SAFETY EVALUATION
FOR THE
GENERAL ELECTRIC TOPICAL REPORT
QUALIFICATION OF THE ONE-DIMENSIONAL
CORE TRANSIENT MODEL FOR
BOILING WATER REACTORS
NEDO-24154 and NEDE-24154-P
Volumes I, II and III

Prepared By
Reactor Systems Branch, OSI

June 1980

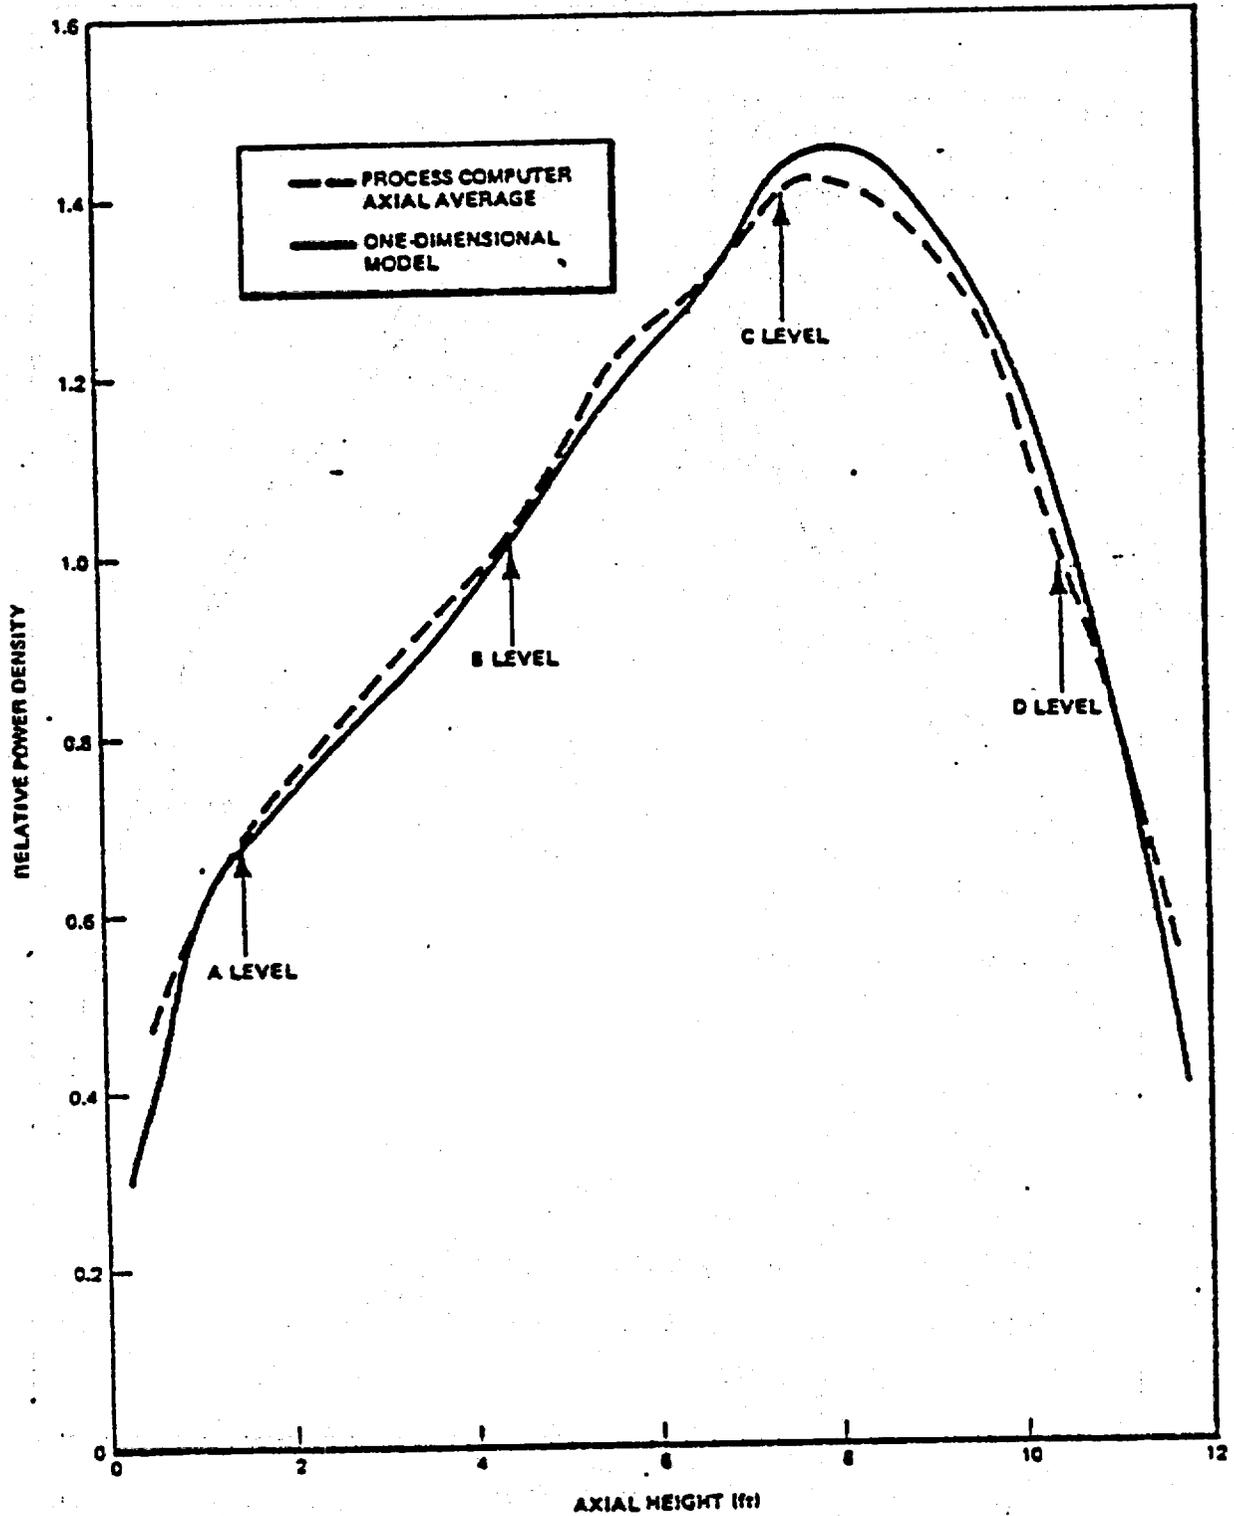
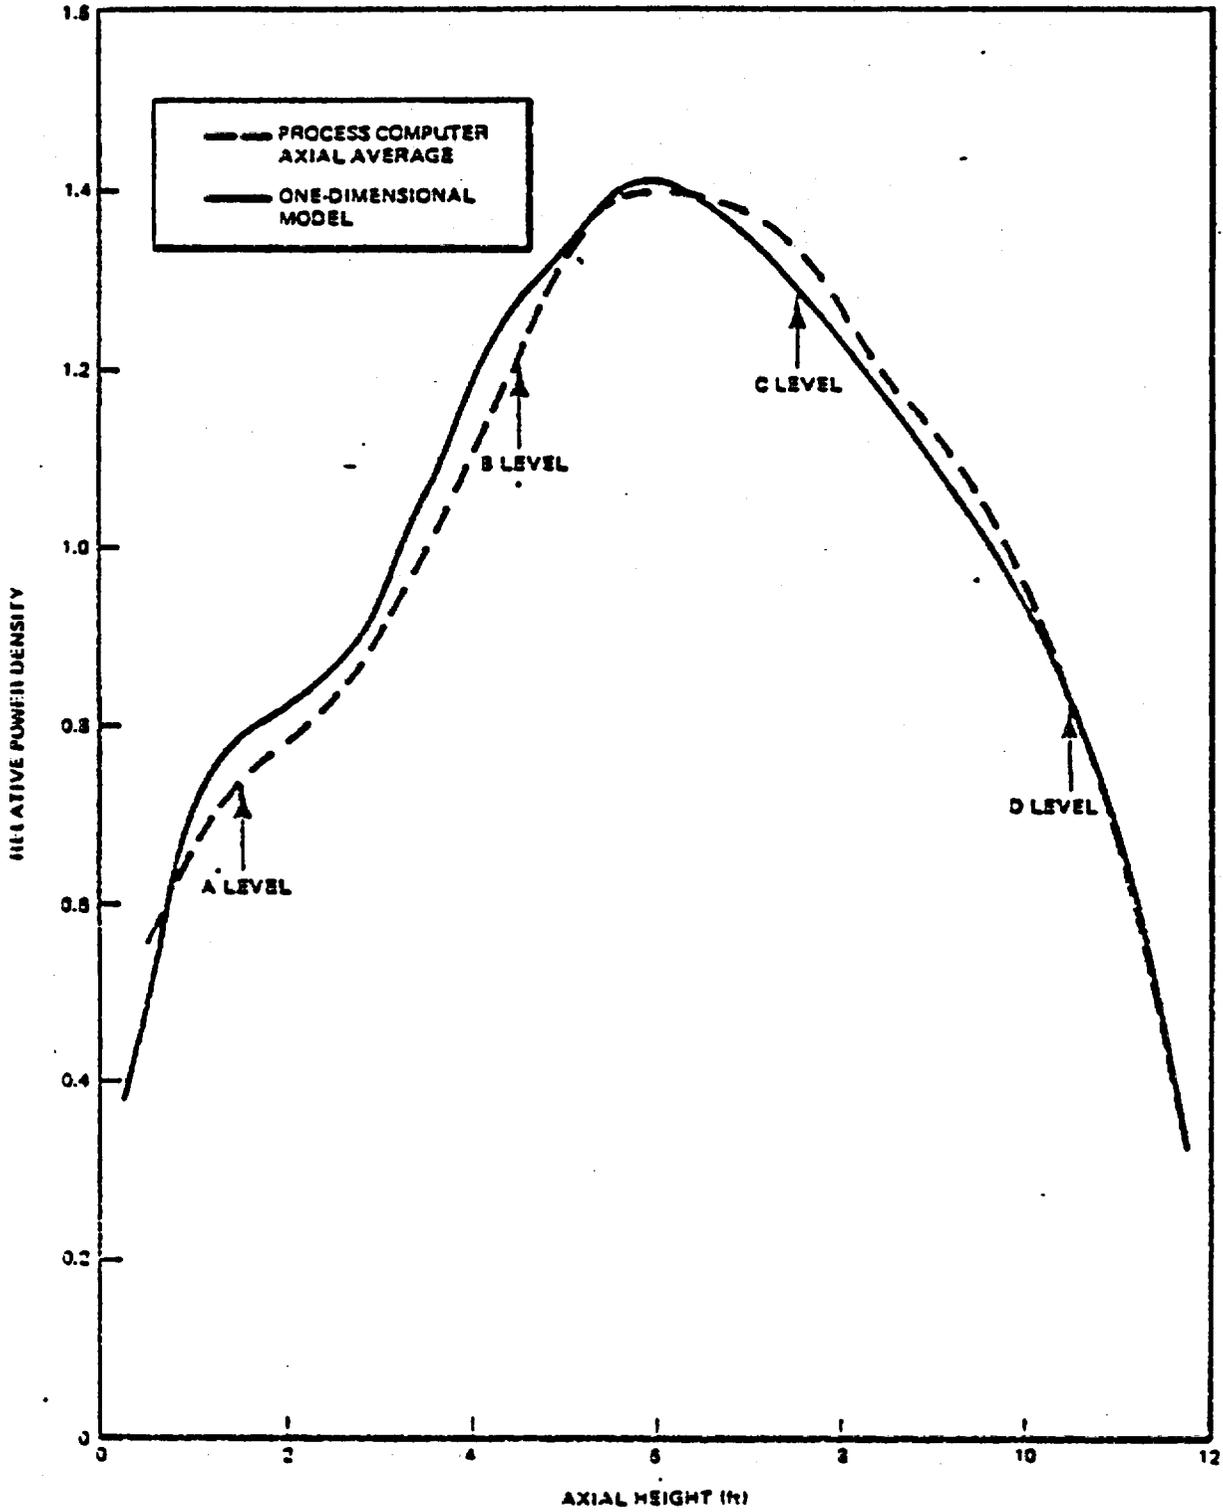
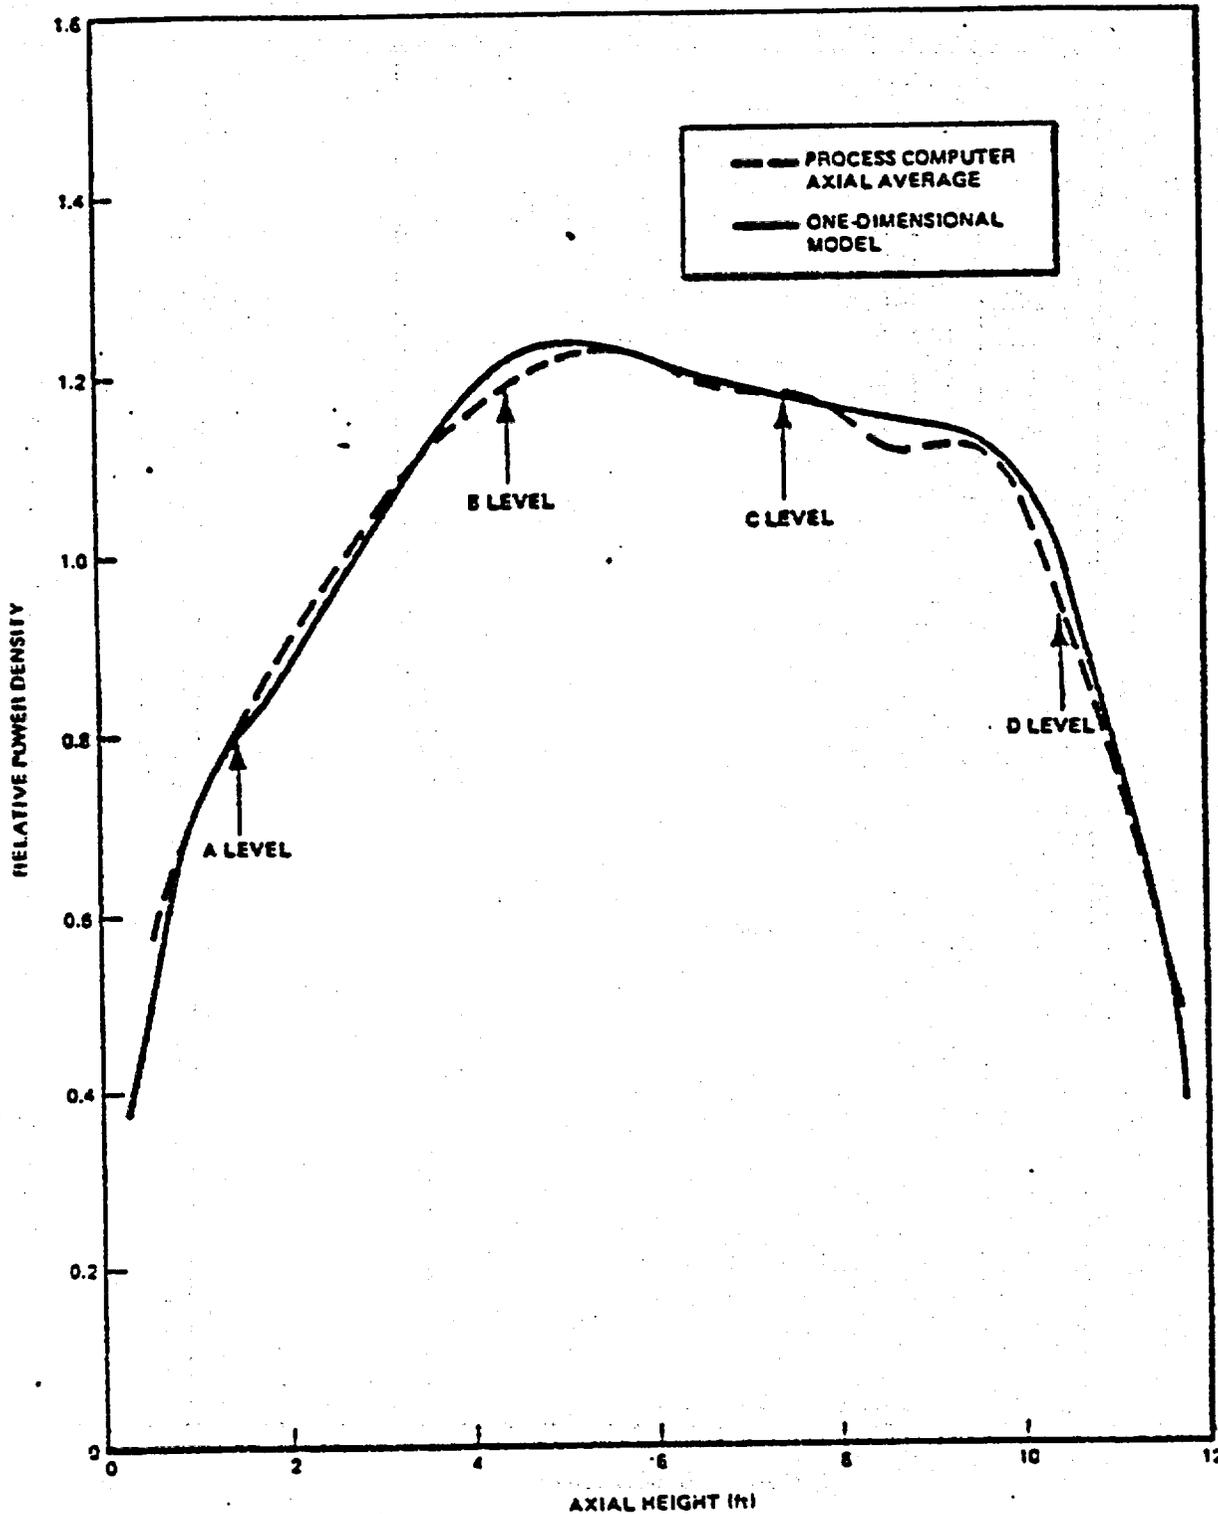
Figures 1 through 3 (reproduced from NEDO-24154) present comparisons of axial neutron flux variations as measured (calculated by the process computer) and calculated by the ODYN code before the initiation of the tests. Figures 4 through 6 present comparisons of prompt neutron power as measured and calculated by the ODYN code during the tests.

Figure 15
11-71

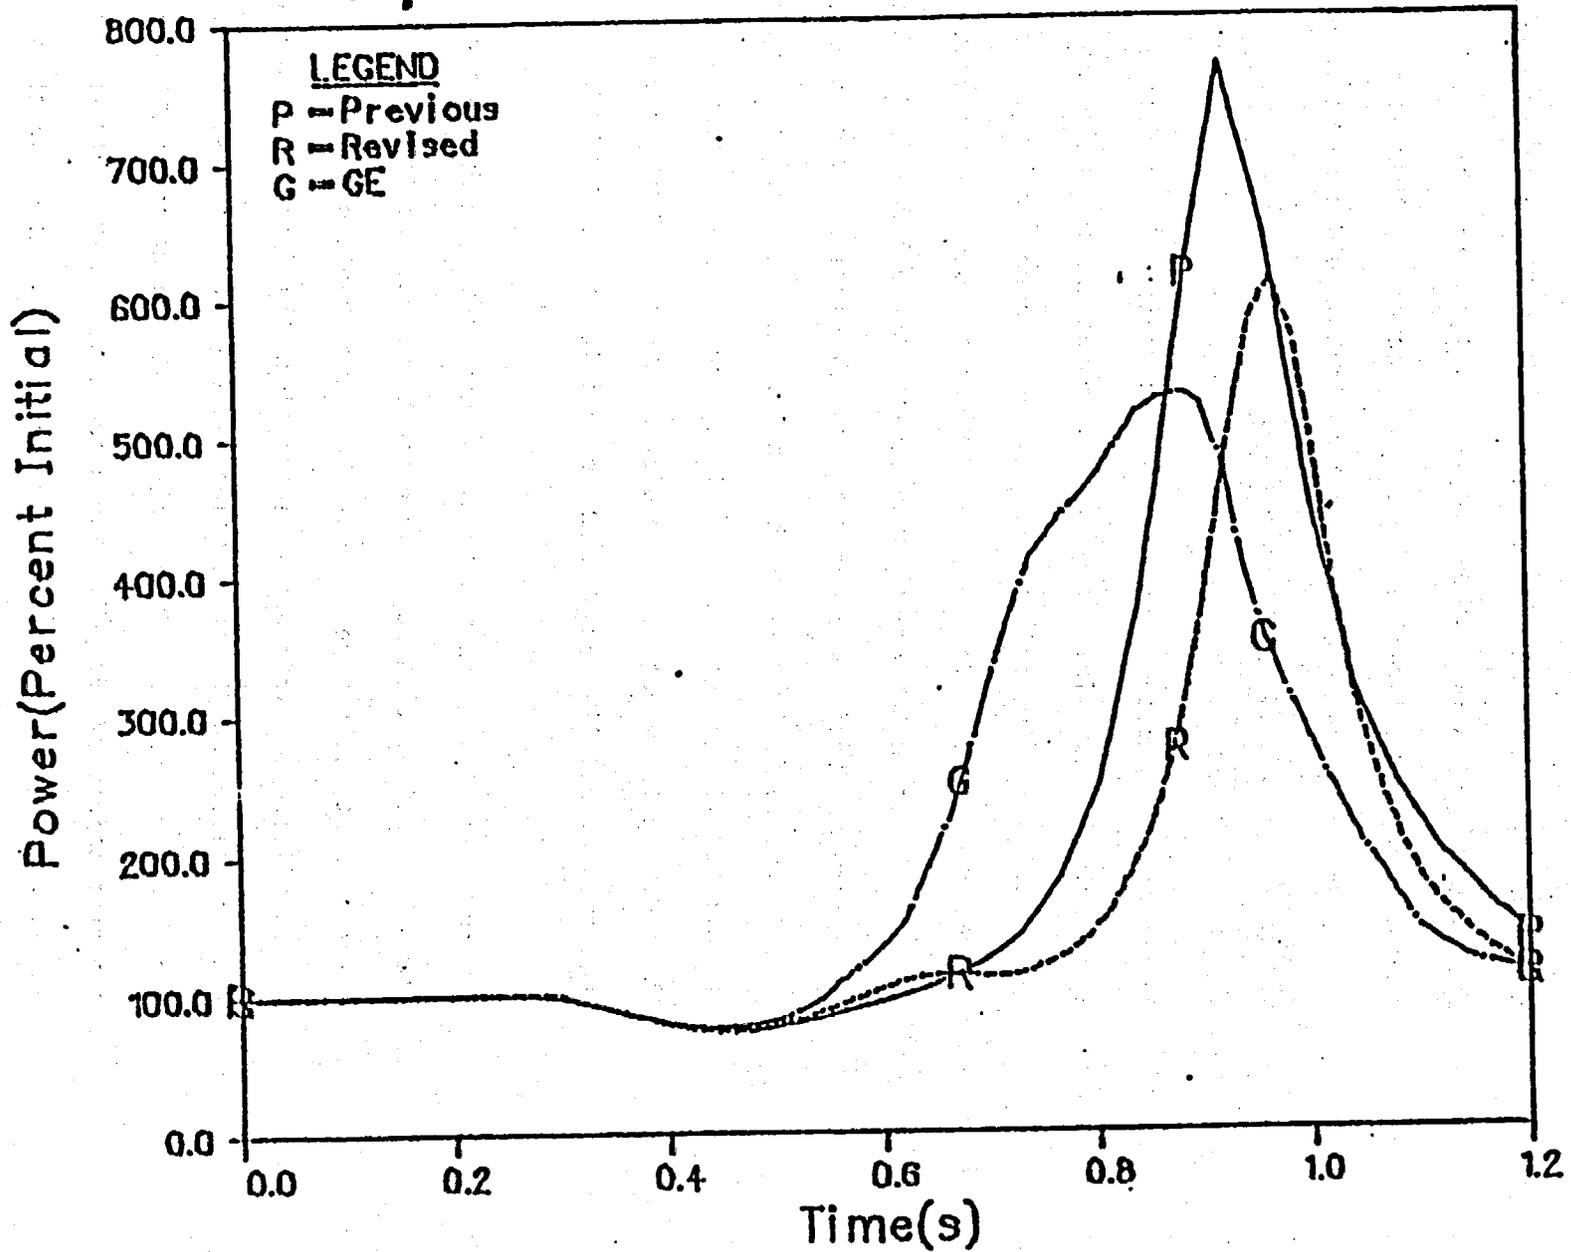
Some sensitivity studies were also performed. Some of the differences noted in the meeting did not change the BNL results substantially. However the difference in the separator inventories and the required renodalization around the separators to accommodate proper inventories inside and outside of the separators and inclusion of a separate flow path between the steam dome and outside of the separators (bulkwater), reduced the neutron power and the total energy output in the licensing basis transient (TTWOB). The total energy output, the integral of the neutron power, predicted by BNL during the transient was less than that in the second calculation performed by General Electric. However, the General Electric calculation still indicated an earlier rise and an earlier fall-off of the total core power than the BNL calculation. Figure 15 presents these two BNL calculations as well as the General Electric calculation.

The primary reason for the change in the energy outputs as well as disagreement in the shape of the neutron power transient was the new inlet core flow calculation by the BNL. The core inlet flow in the second BNL calculation was in closer agreement with the second GE calculation in that it exhibited similar oscillatory behavior.
